THUNDERBIRD OFFICE PARK
AN ADDITION TO WICHITA, SEDGWICK COUNTY, KANSAS

RE: SUB 2001-109 -- Final Plat of Thunderbird Office Park Addition

At the regular meeting of the Subdivision Committee of the Metropolitan Area Planning Commission on Thursday, December 13, the above captioned plat was considered. The action of the Committee was to approve the final plat, subject to the following:

CASE NUMBER: SUB 2001-109 – THUNDERBIRD OFFICE PARK ADDITION

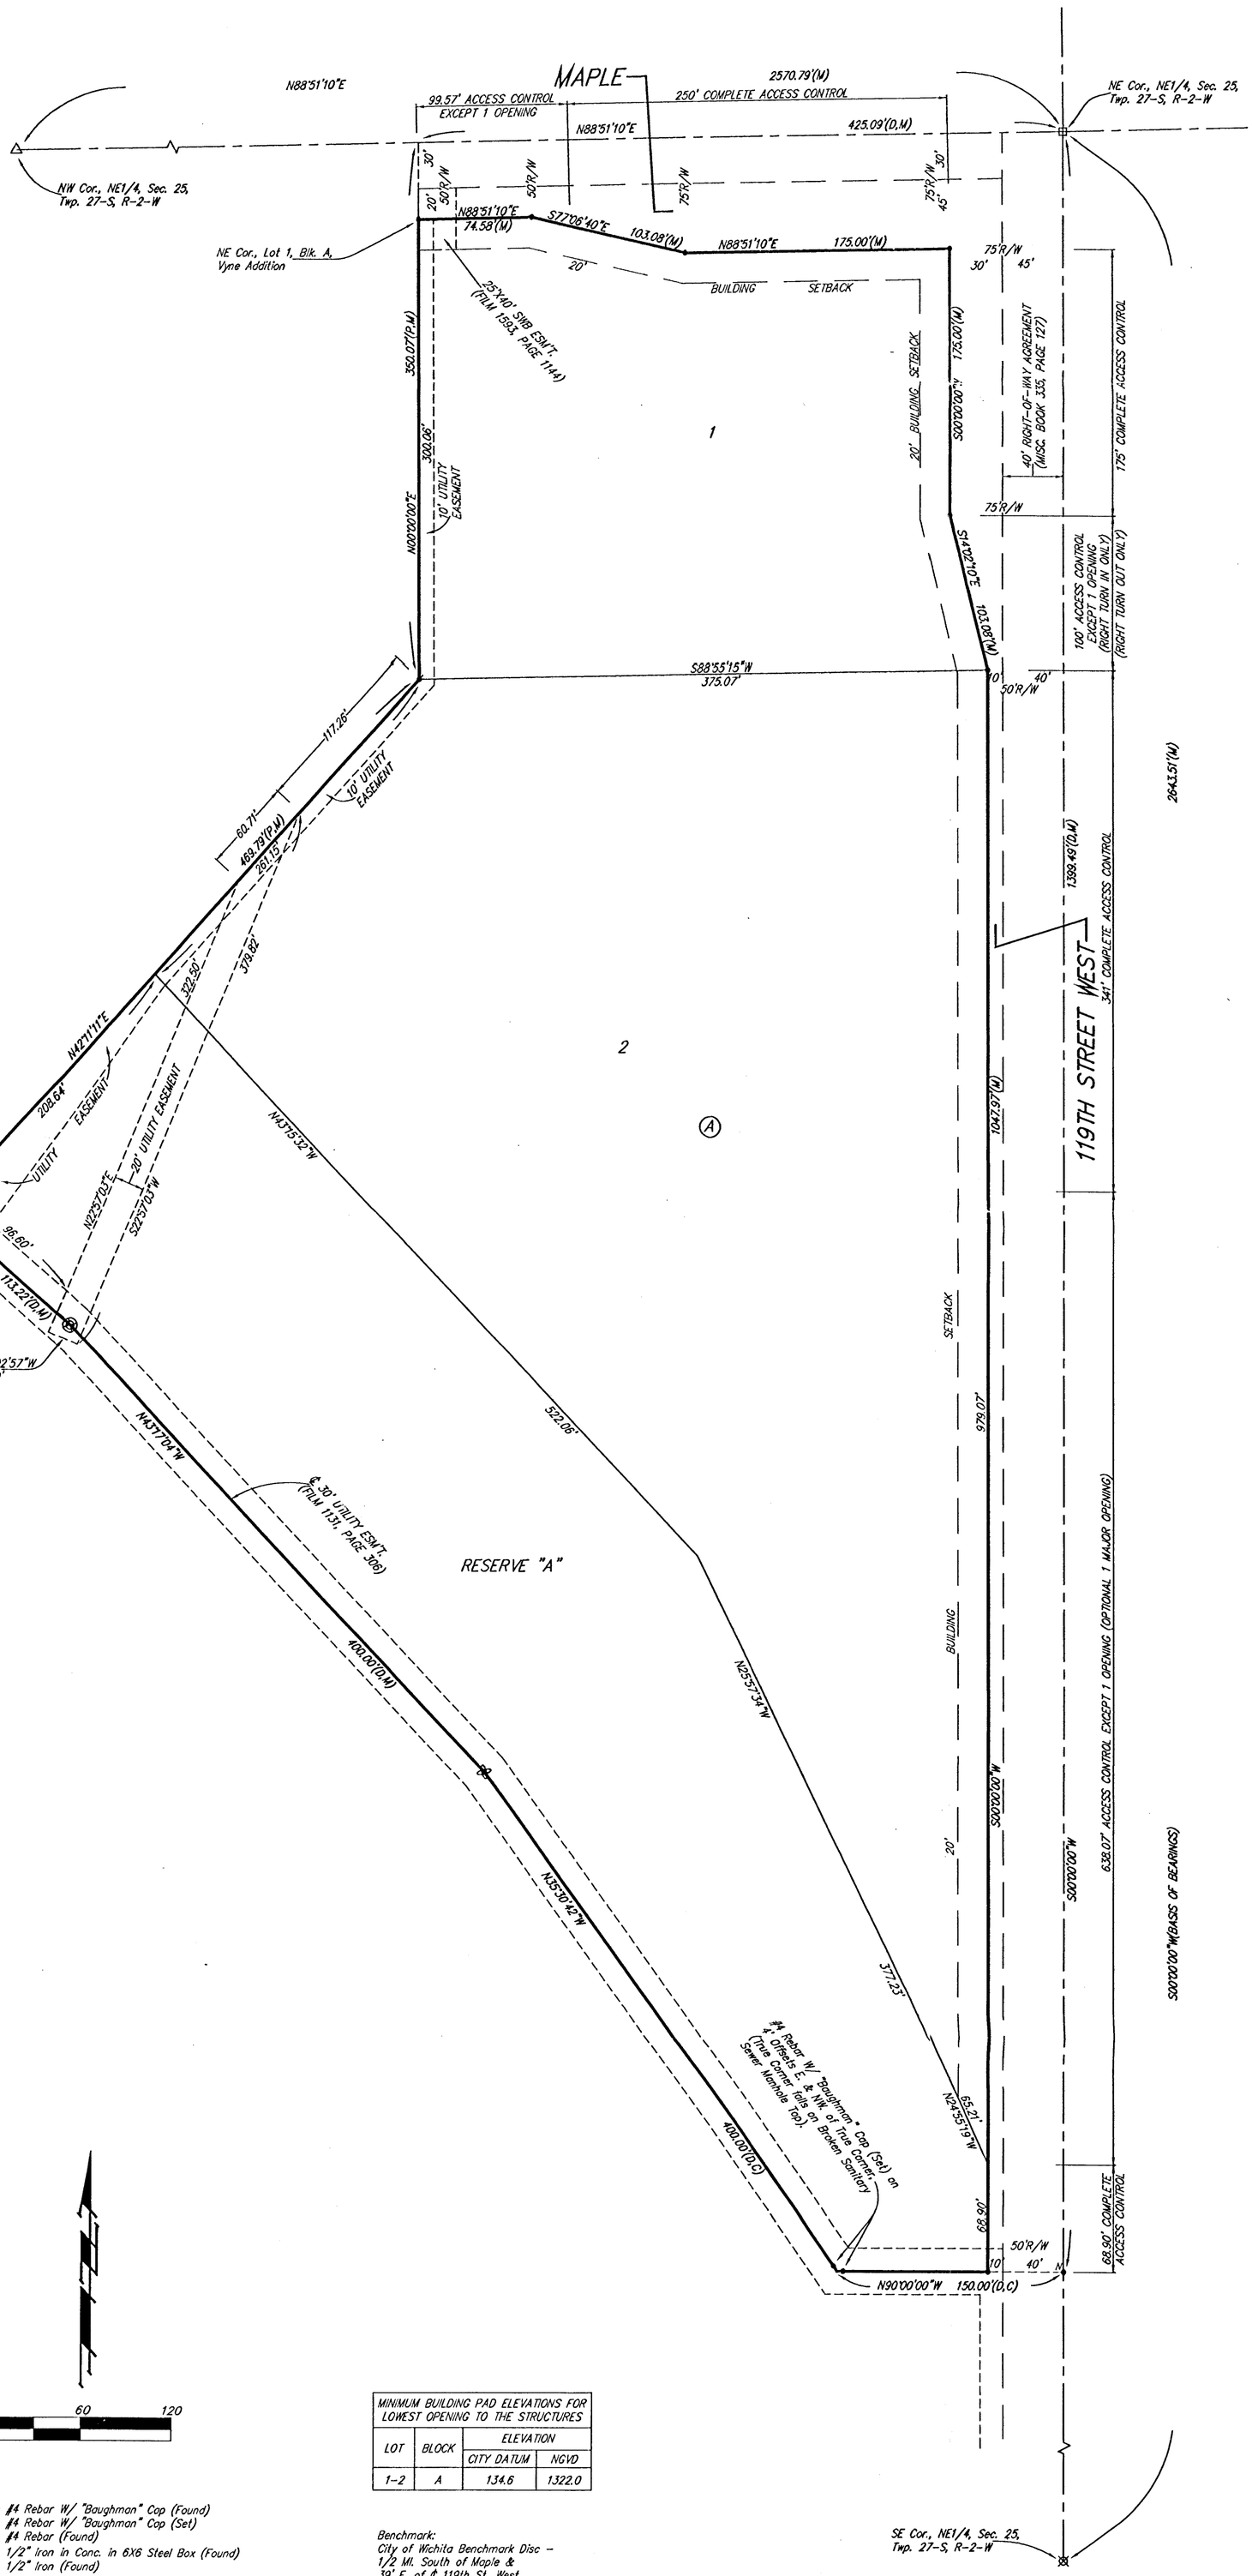
A. City Engineering needs to comment on the need for guarantees or easements. *A guarantee needs to be provided for extension of sanitary sewer and City water.*

C. City Engineering needs to comment on the status of the applicant's drainage plan. *A drainage guarantee is required.*

D. County Surveying has advised that the sanitary sewer easement needs to be located.

E. A dimension is needed along the south line of Reserve A.

F. The plat proposes two access openings along 119th St. West and one opening along Maple. *The northerly opening may be retained subject to right turns only and construction of a median extension. A cross-lot access agreement shall be provided between Lots 1 and 2.*

J. The plattor's text shall include language that a drainage plan has been developed for the plat and that all drainage easements, rights-of-way, or reserves shall remain at established grades or as modified with the approval of the applicable City or County Engineer, and unobstructed to allow for the conveyance of stormwater.
